S303-S159

SERVICE**TECHNICAL BULLETIN**

Engine In Limp Home/Check Engine MIL –
Water Ingress into Throttle Position Sensor –
Service Action S159

MODEL 2003-04 MY
S-TYPE R

ILLUSTRATION 1

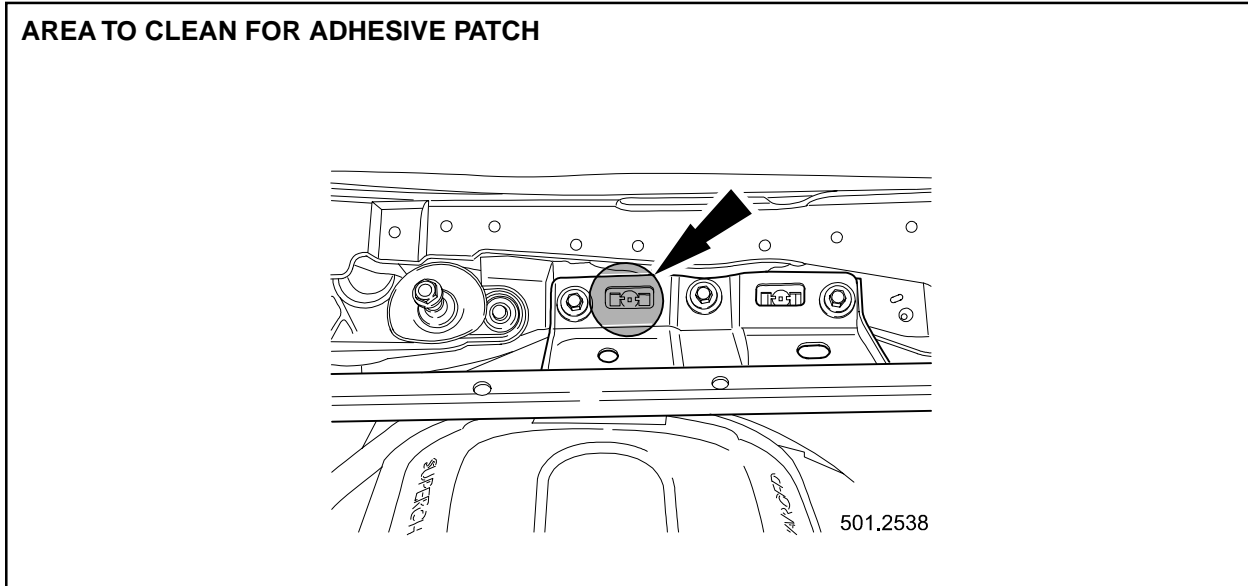
A concern has been identified on 2003-04 MY S-TYPE R vehicles within the above VIN range. It is possible that during washing of the vehicle, by car wash or jet wash, the water can run through the cowl panel grille-fixing hole into the throttle position sensor housing. This can result in the throttle position sensor failing to function, the engine management system defaults to 'limp home' mode, and a warning MIL is displayed.

A sealing patch is available to prevent water flowing directly from the cowl panel grille onto the throttle position sensor.

On 2003-04 MY S-TYPE R vehicles within the above VIN range, install a sealing patch on the mounting hole located on the suspension turret cross brace at the bracket securing it to the bulkhead.

- Clean the area indicated on the bracket of the suspension turret cross brace where it secures to the bulkhead (Illustration 1).

- Ensure the plastic insert is central in the rectangular hole of the brace.
- Remove and discard the backing from the adhesive patch and install the patch centrally over the right hand rearmost rectangular hole (Illustration 1) of the suspension turret cross brace.
- Reinstall the cowl panel grille, see Workshop Manual, JTIS CD ROM, section: 501-02, SRO 76.10.01.
- Remove fender protection kit and close hood and door.
